W-1 LEON CREEK: HWY 151 TO HWY 90 - UPPER SEGMENT

Solicitation Number: CO-00351

Job No.: 19-4528

ADDENDUM 1

SAWS JOB NO. 19-4528
W-1 LEON CREEK: HWY 151 TO HWY 90
UPPER SEGMENT
LINE "A" PLAN AND PROFILE
STA 54+00 TO STA 58+00

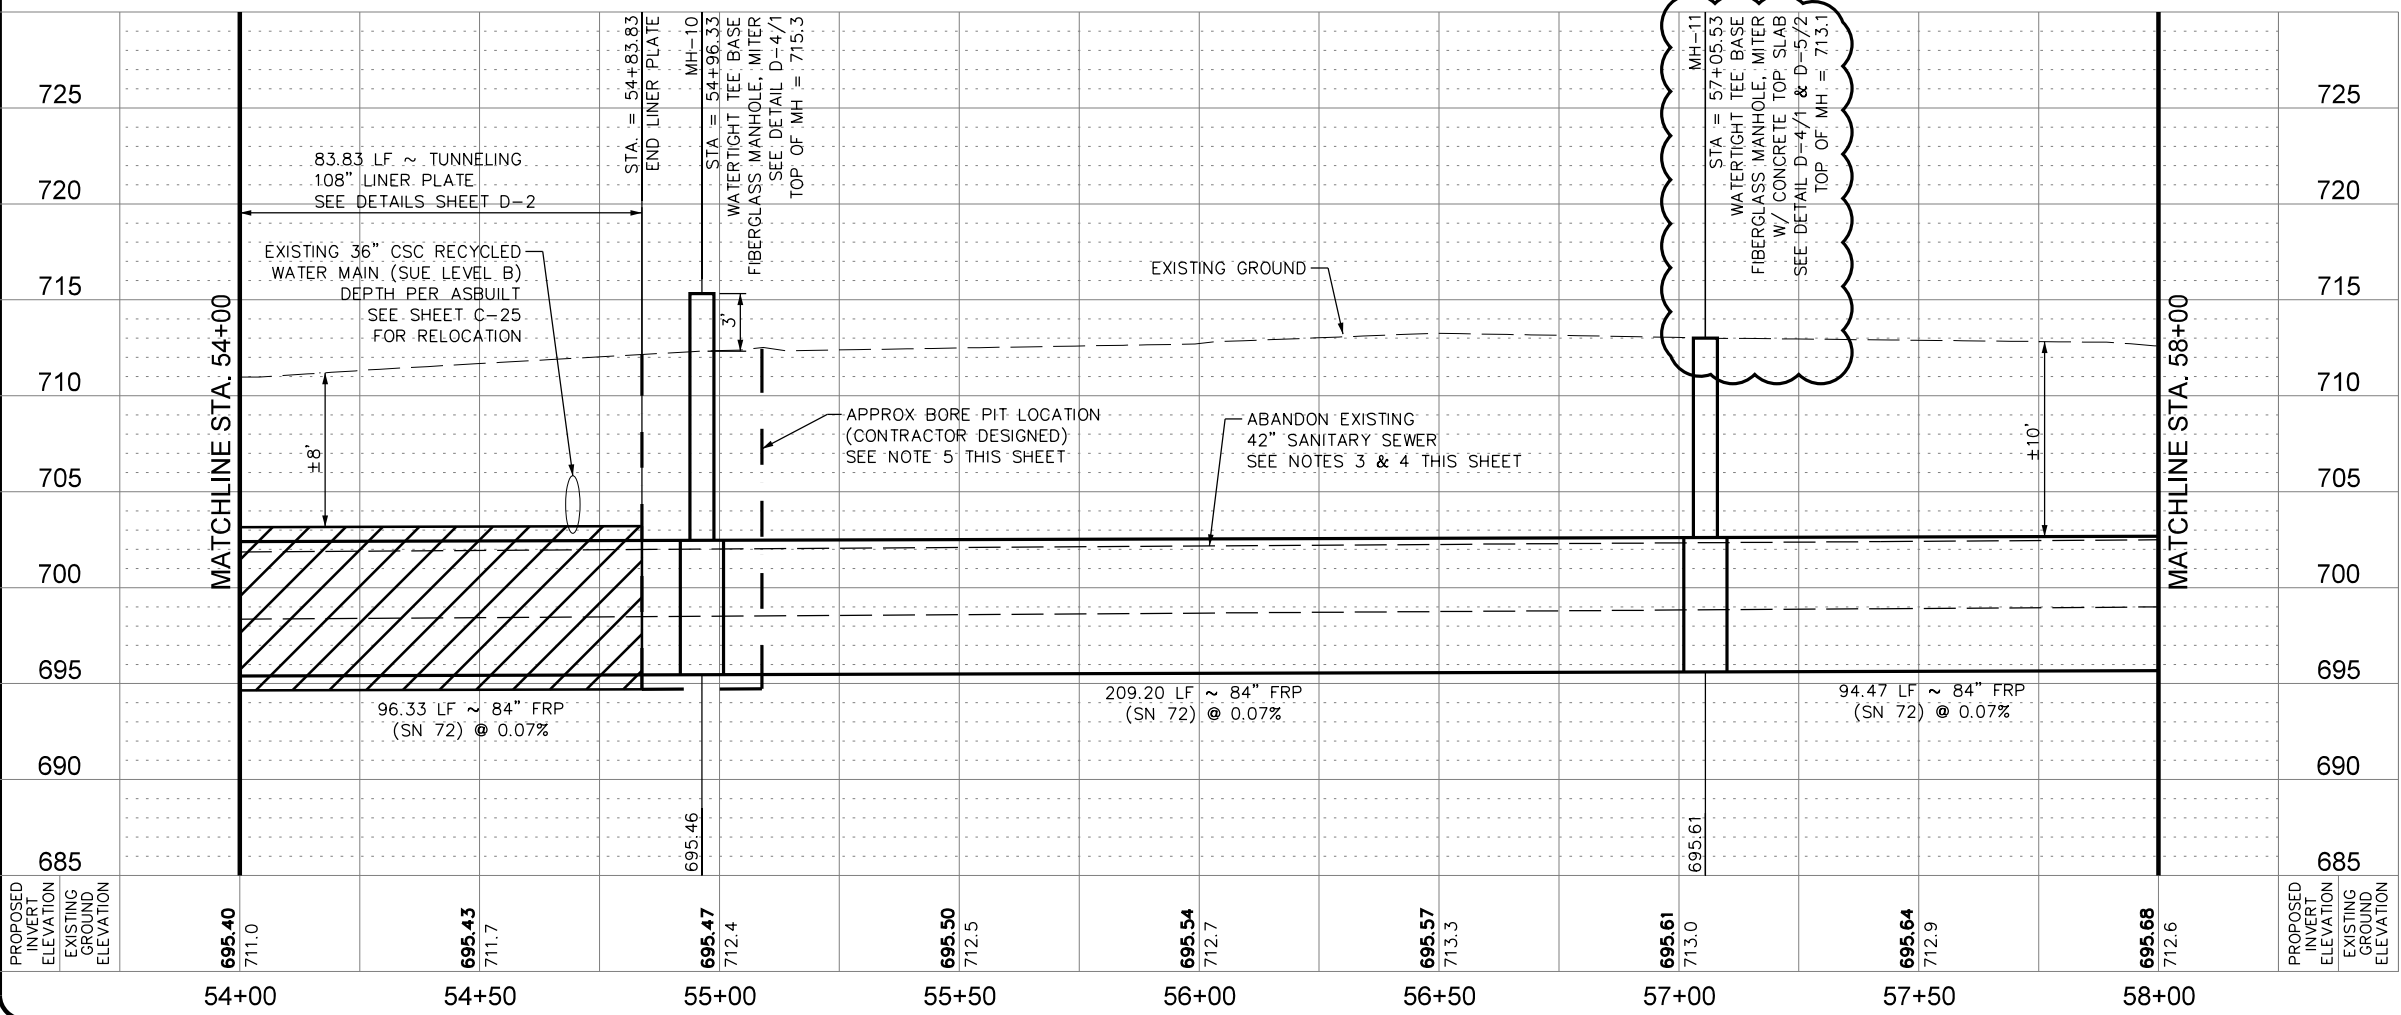
- Sheet C-12: Line “A” Plan and Profile Sheet STA 54+00 to 58+00 – Replace sheet in its entirety.
 - Added concrete top slab to MH-11
 - Added Line Item D-5 – Concrete Manhole Top Slab to Quantity Table

SAWS JOB NO. 19-4528
W-1 LEON CREEK: HWY 151 TO HWY 90
UPPER SEGMENT
LINE "A" PLAN AND PROFILE
STA 70+00 TO STA 74+00

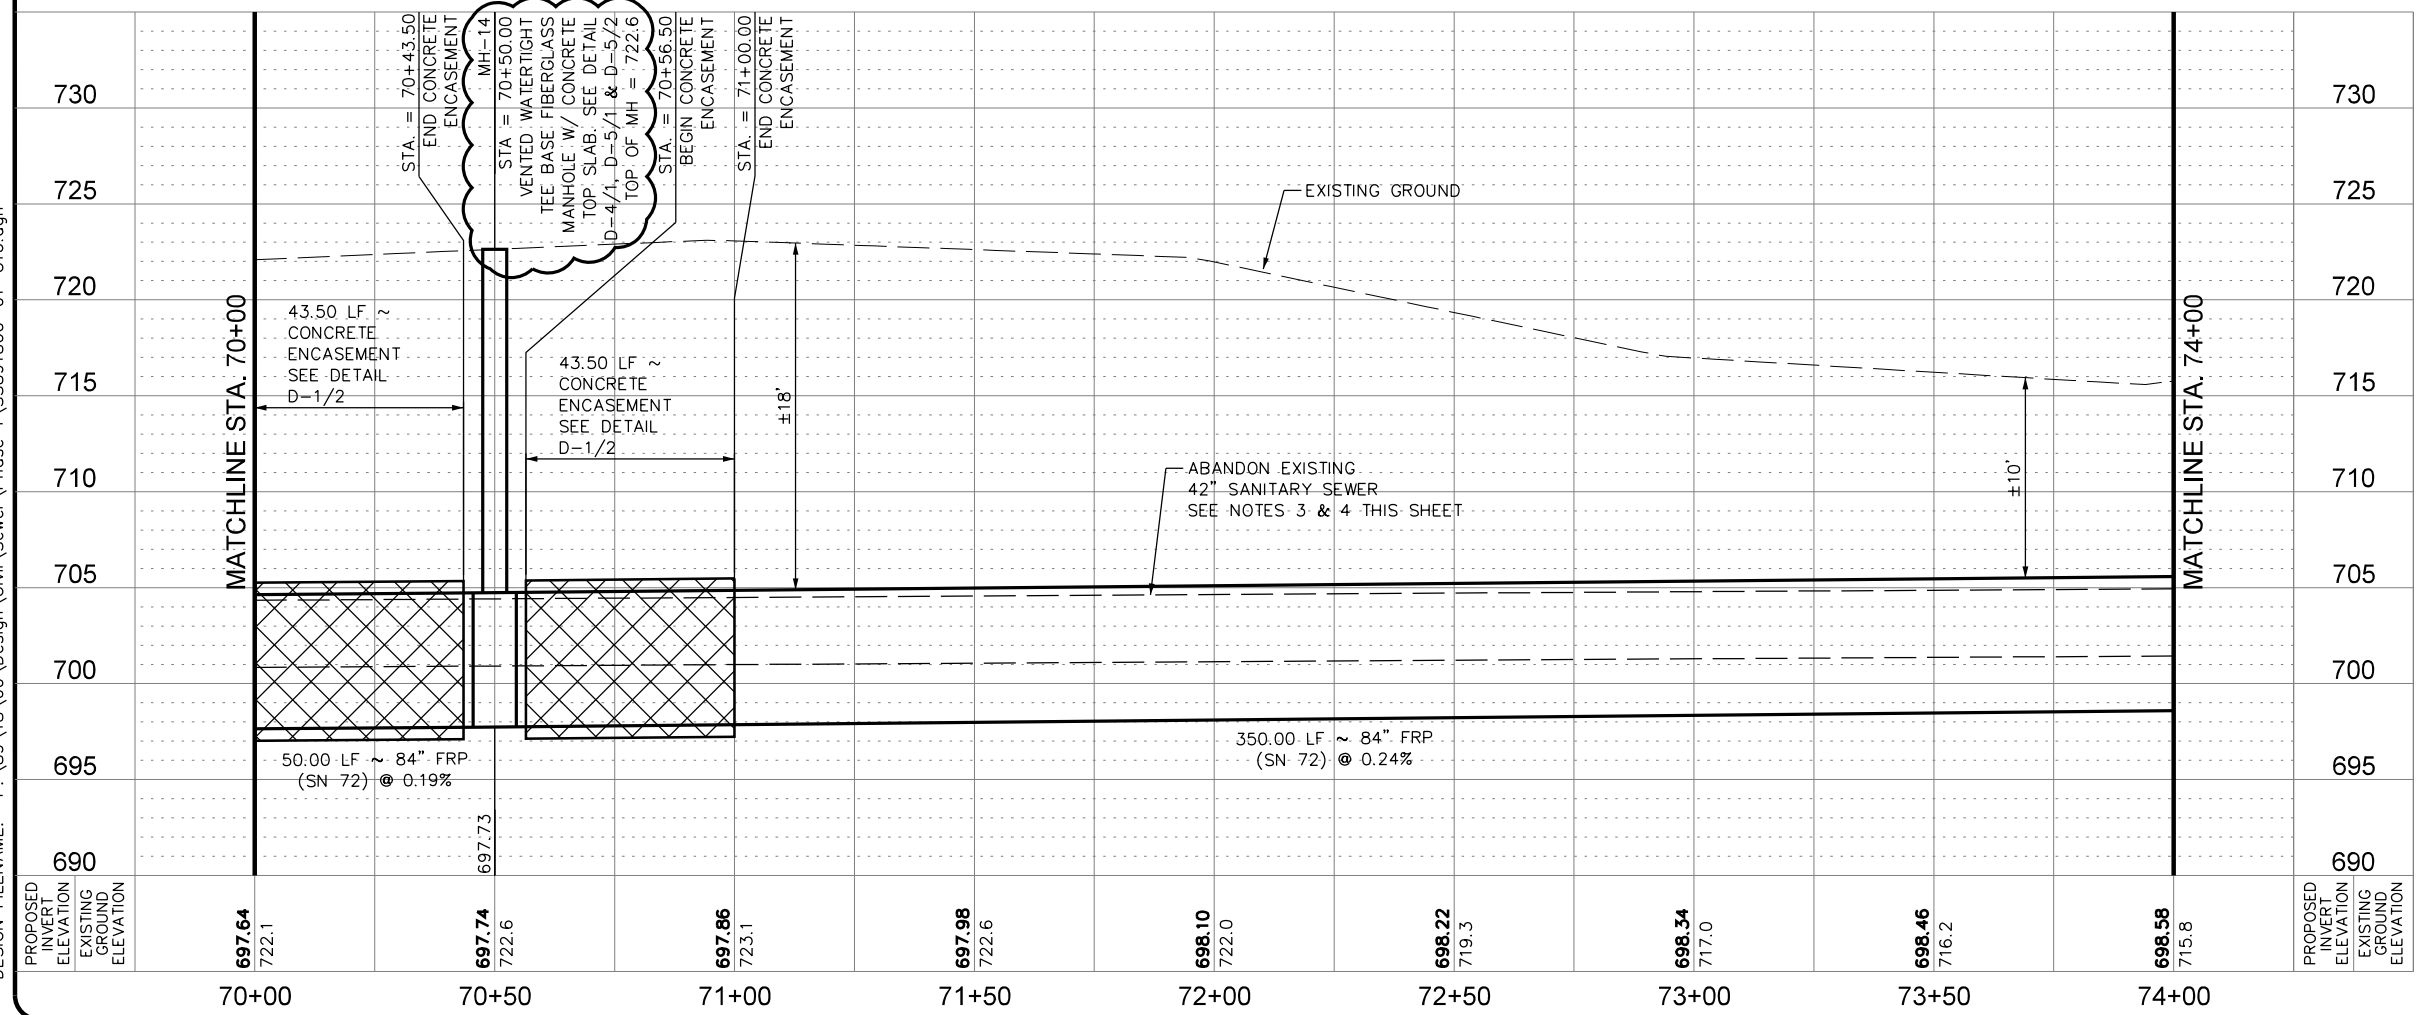
- Sheet C-16: Line “A” Plan and Profile Sheet STA 70+00 to 74+00 - Replace sheet in its entirety.
 - Added concrete top slab to MH-14
 - Added Line Item D-5 – Concrete Manhole Top Slab to Quantity Table

SAWS JOB NO. 19-4528
W-1 LEON CREEK: HWY 151 TO HWY 90
UPPER SEGMENT
LINE "A" PLAN AND PROFILE
STA 74+00 TO STA 78+00

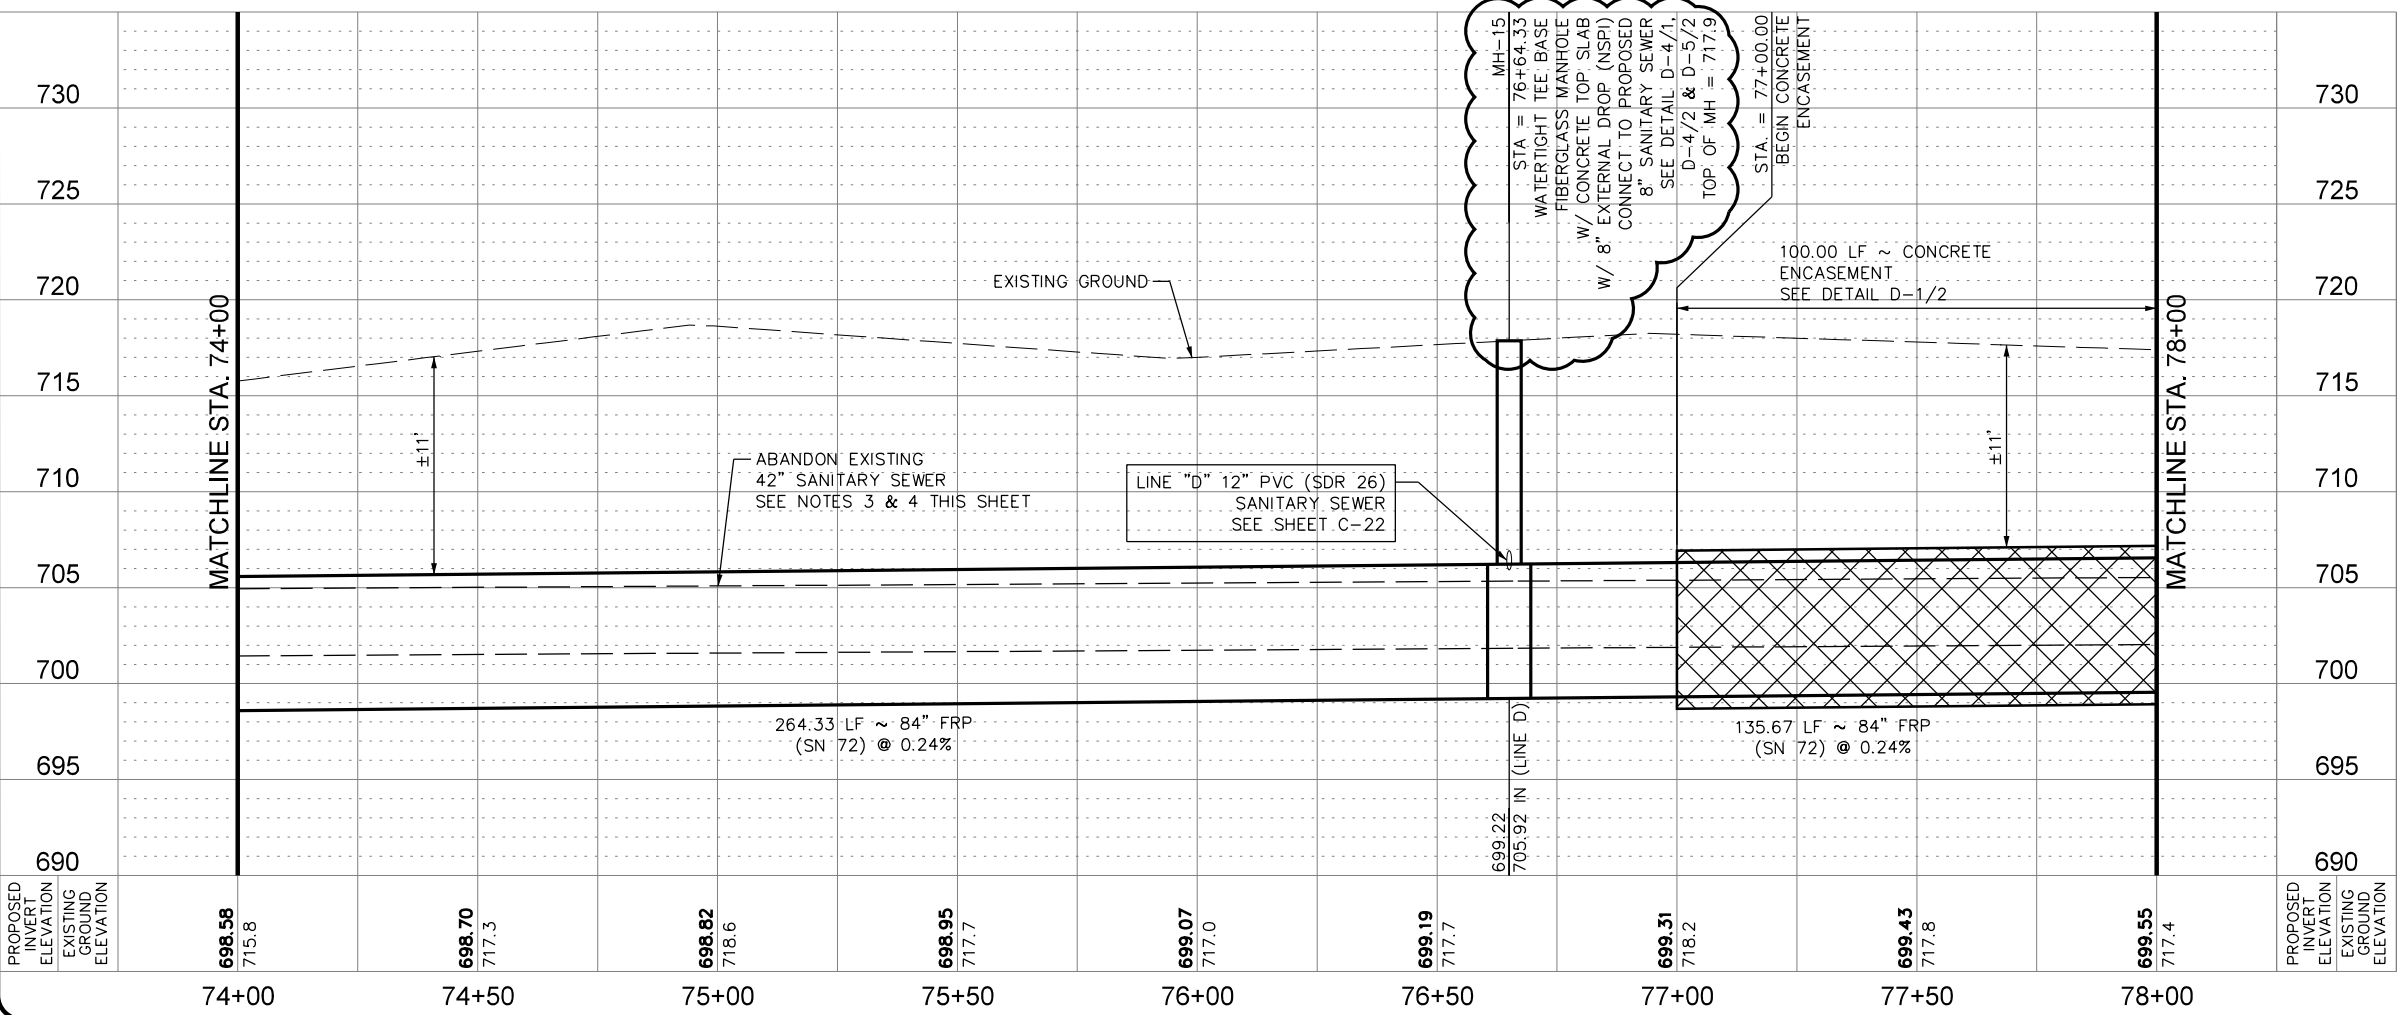
- Sheet C-17: Line “A” Plan and Profile Sheet STA 74+00 to 78+00 – Replace sheet in its entirety.
 - Added concrete top slab to MH-15
 - Added Line Item D-5 – Concrete Manhole Top Slab to Quantity Table

SAWS JOB NO. 19-4528
W-1 LEON CREEK: HWY 151 TO HWY 90
UPPER SEGMENT
LINE "A" PLAN AND PROFILE SHEET
STA 86+00 TO STA 88+07.68

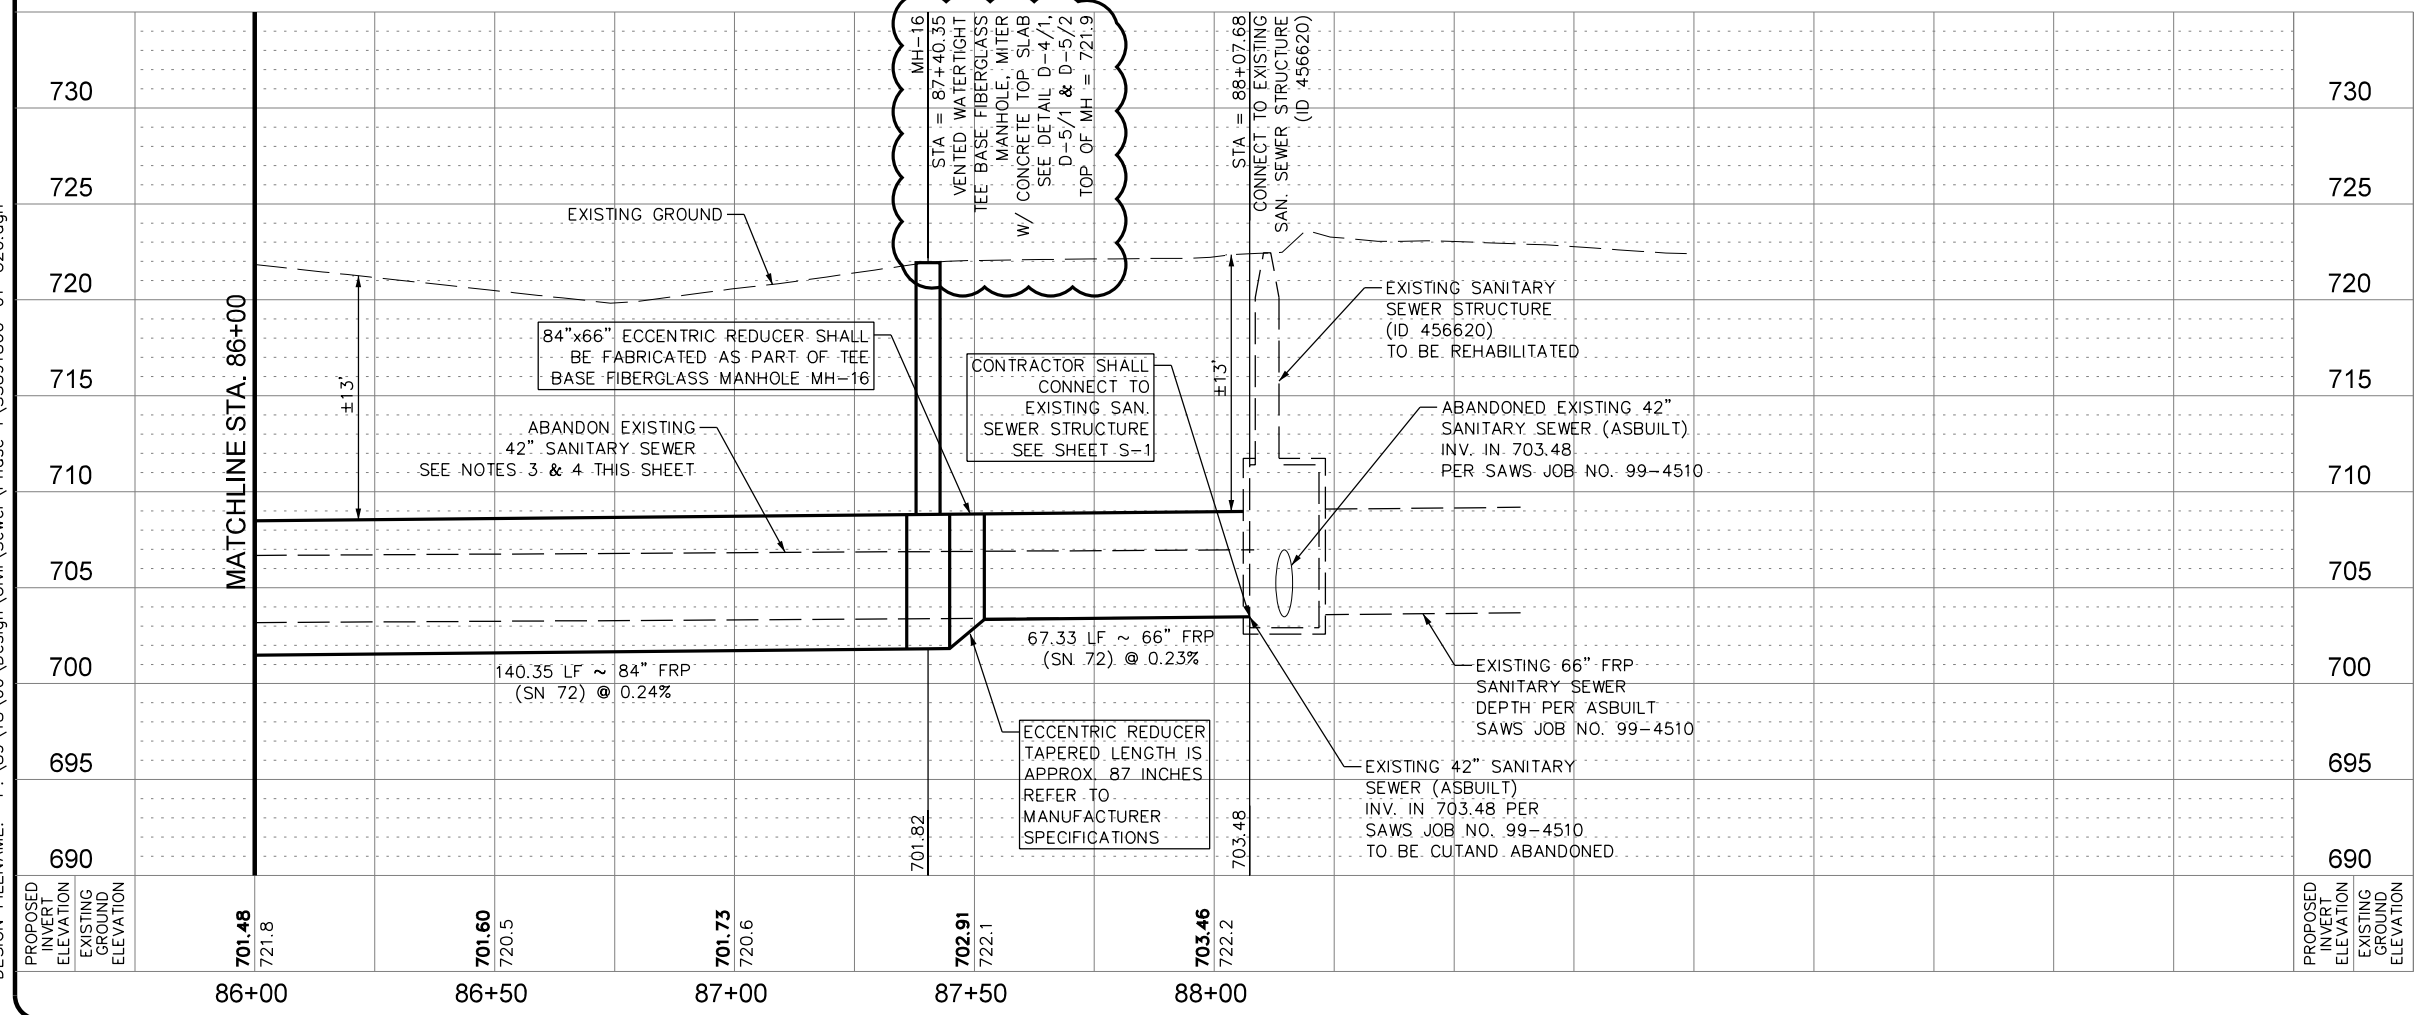
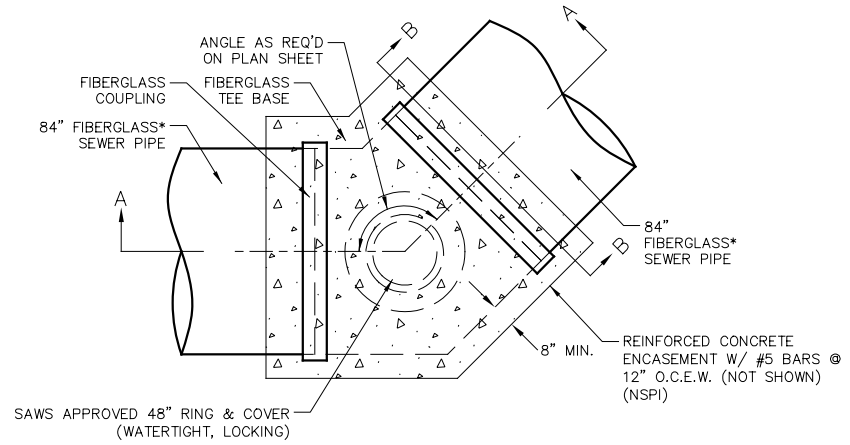
- Sheet C-20: Line “A” Plan and Profile Sheet STA 86+00 to 88+07.68 – Replace sheet in its entirety.
 - Added concrete top slab to MH-16
 - Added Line Item D-5 – Concrete Manhole Top Slab to Quantity Table
